# **PRELIMINARY DRAINAGE PLAN PUD/SP 22-001**

## **HILLSIDE AT LORSON RANCH**

**JANUARY, 2022  
REVISED APRIL, 2022**

**POND E1**  
**POND FOREBAY DETAILS**

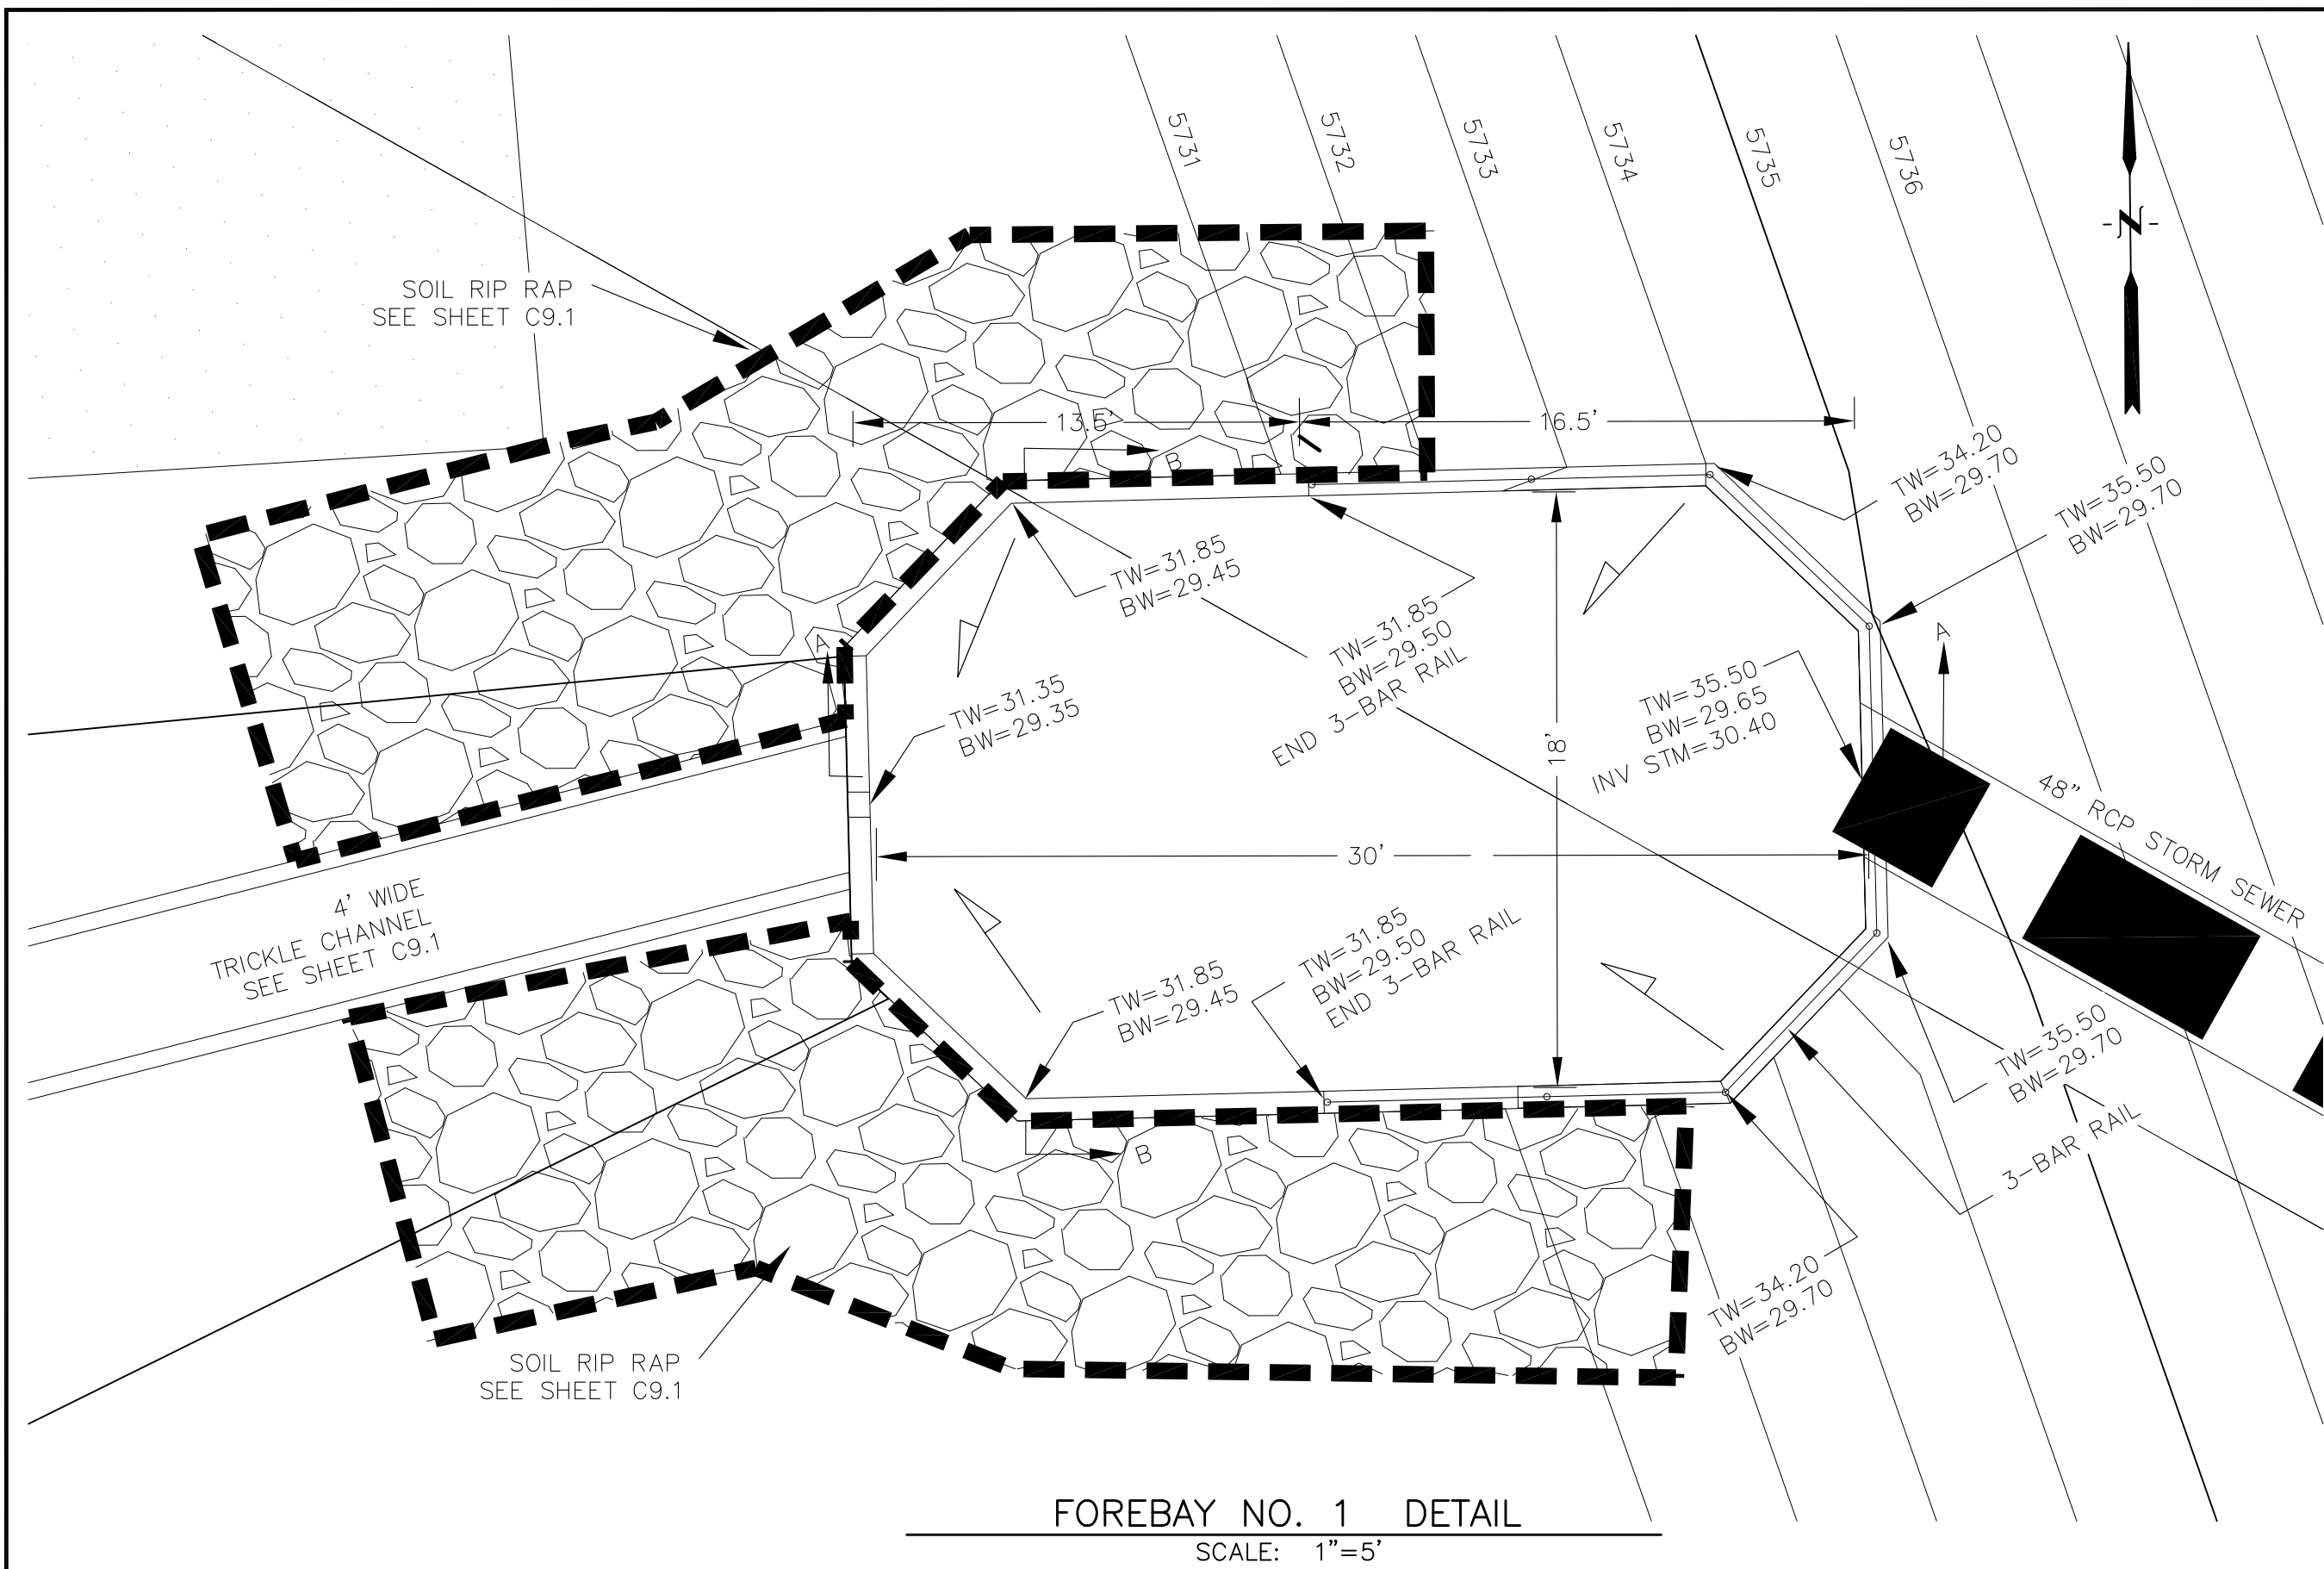
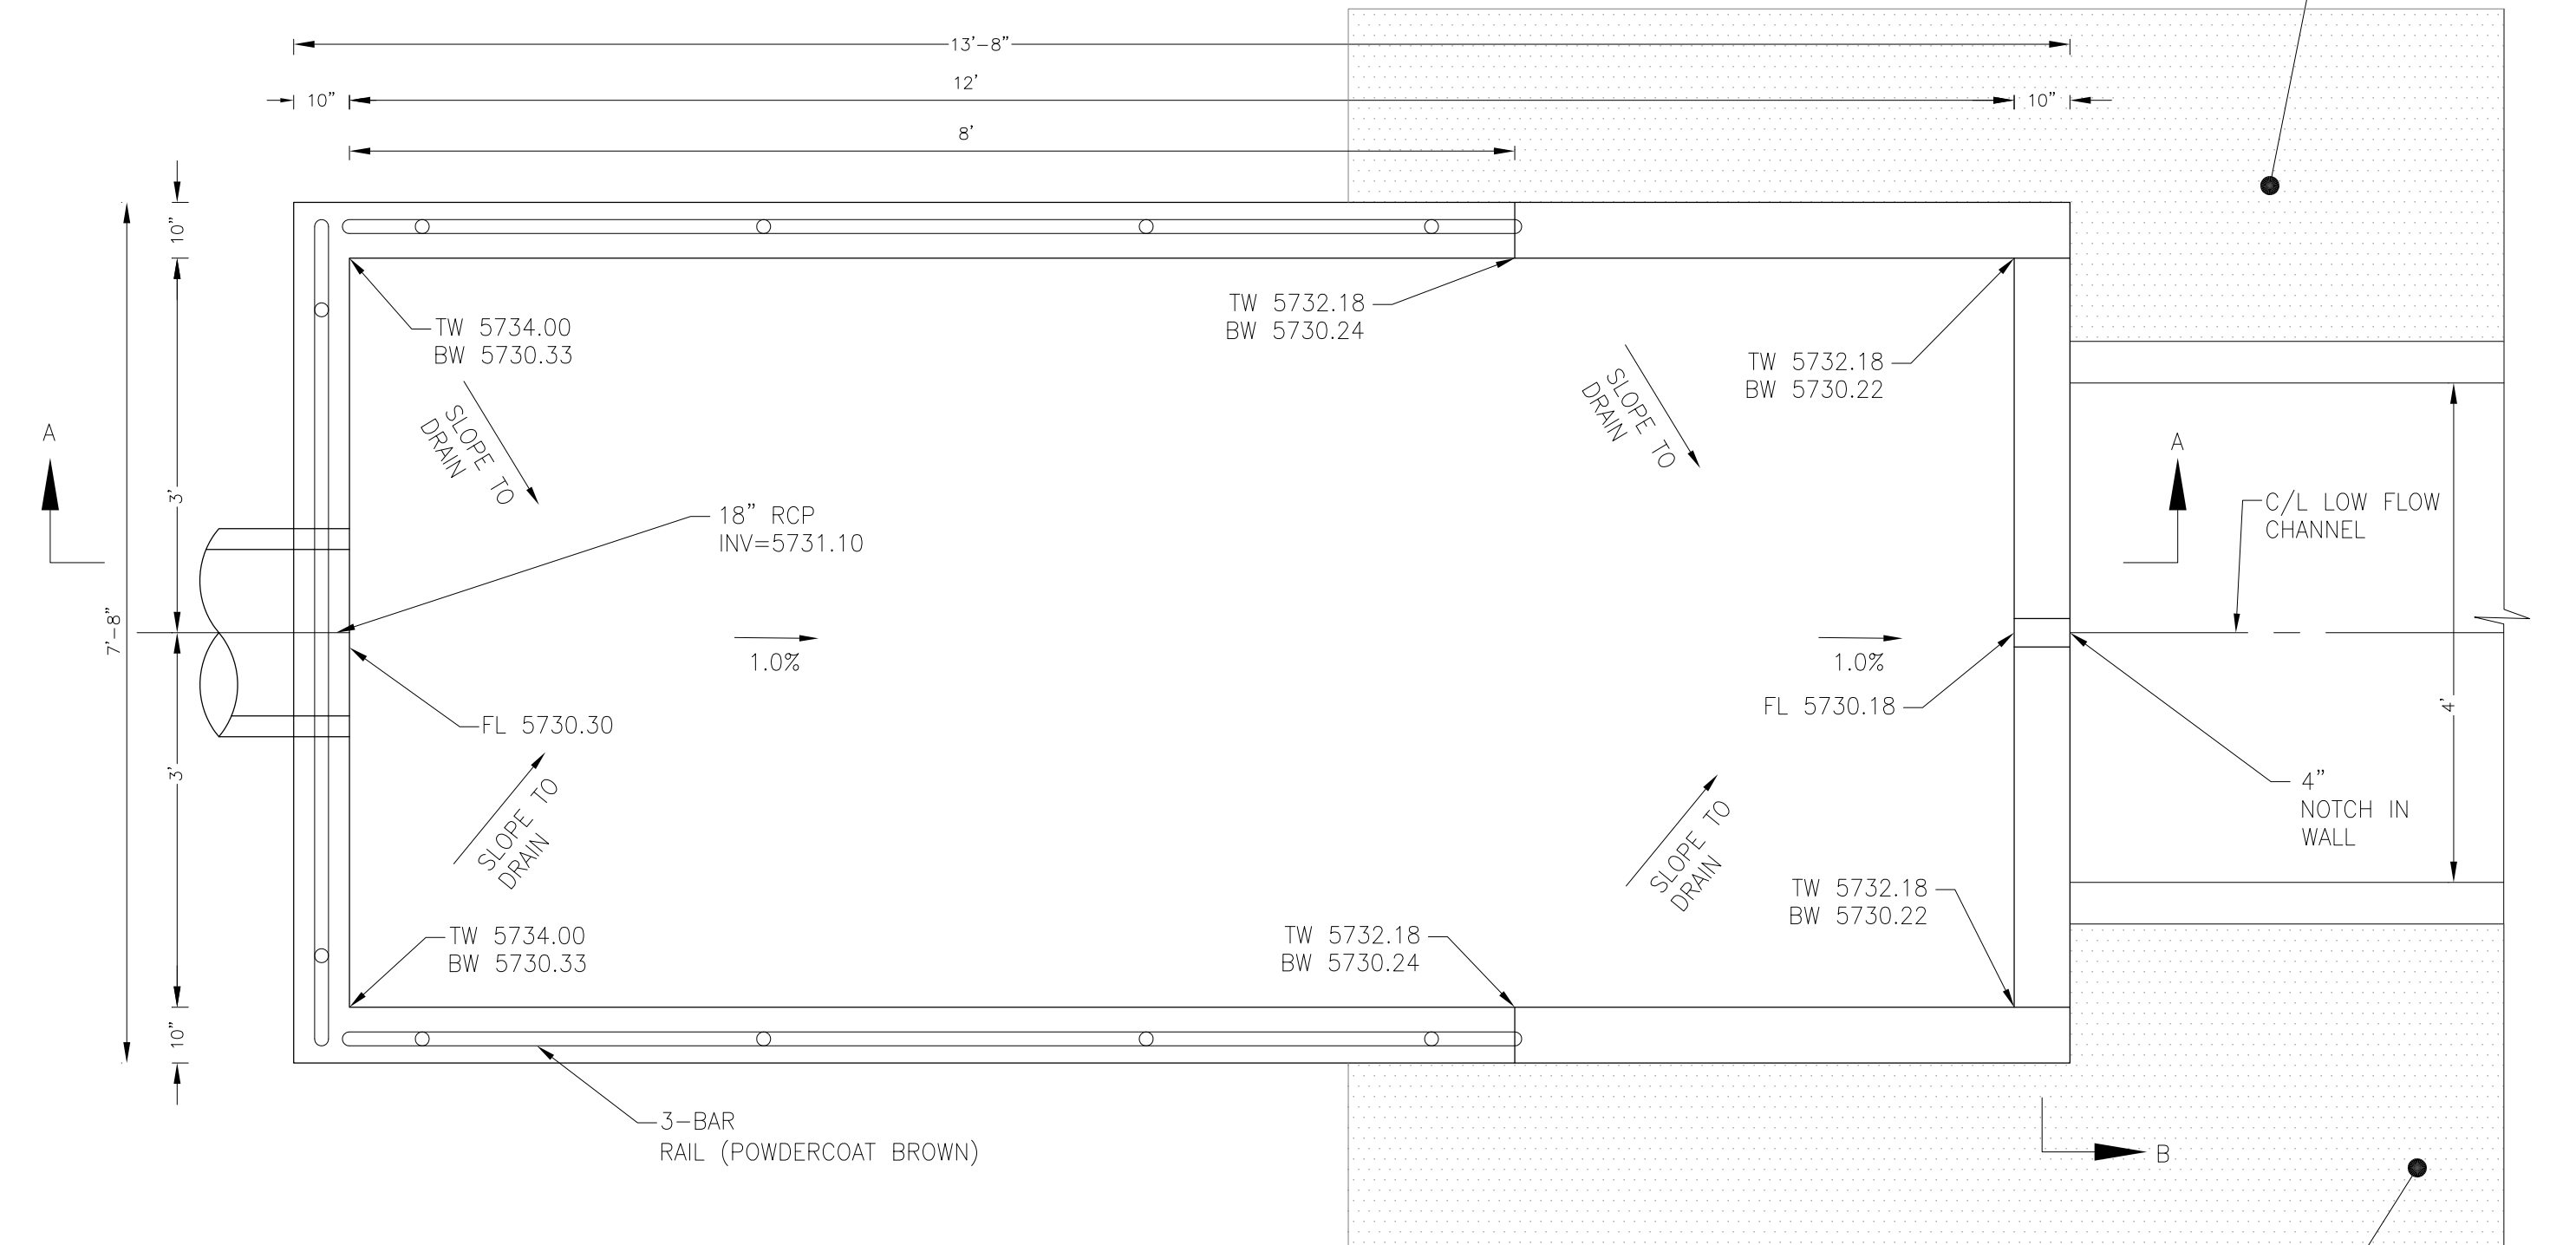
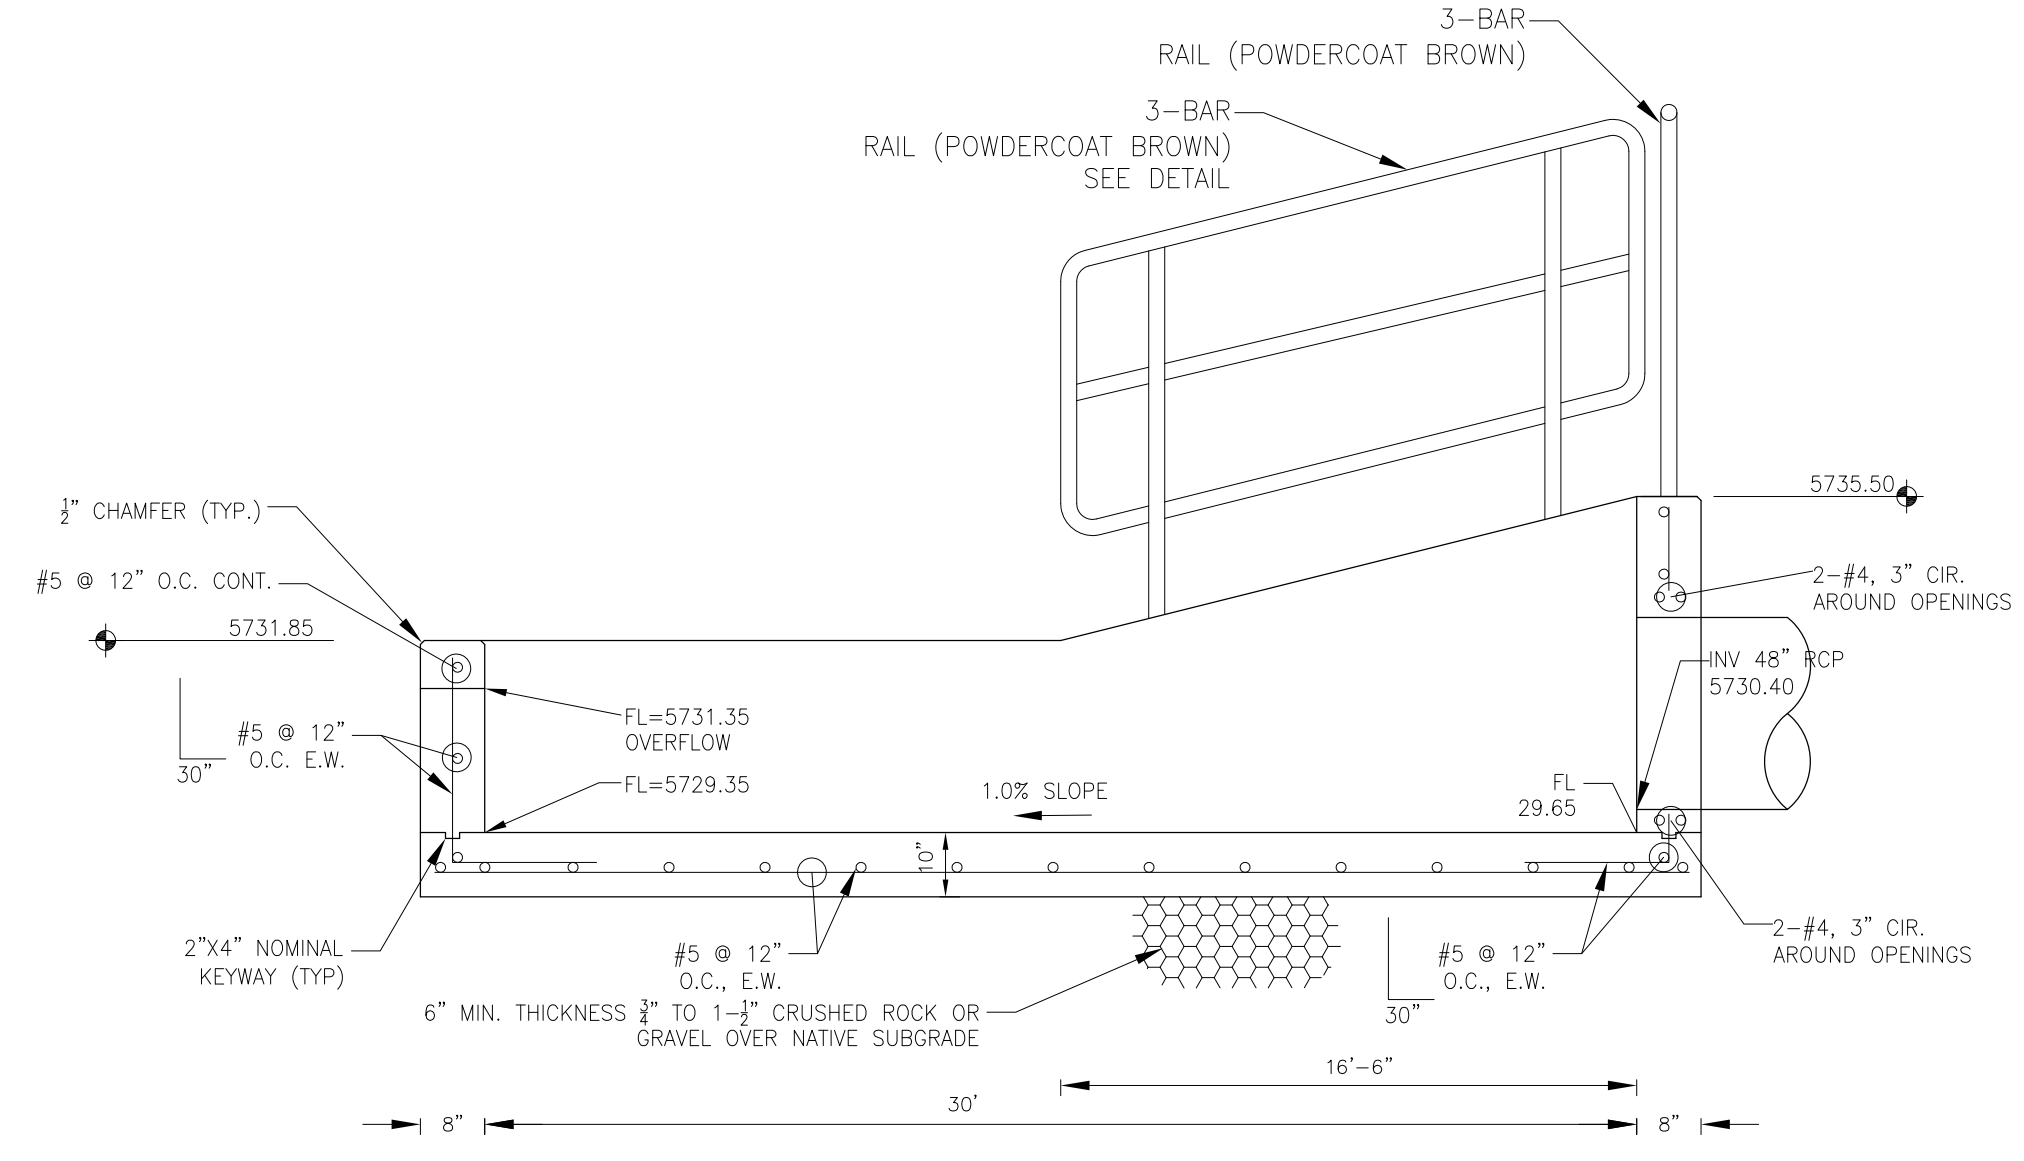
does not match what is shown on Sht C9.2 of GEC Plans. Revise to remove discrepancy.
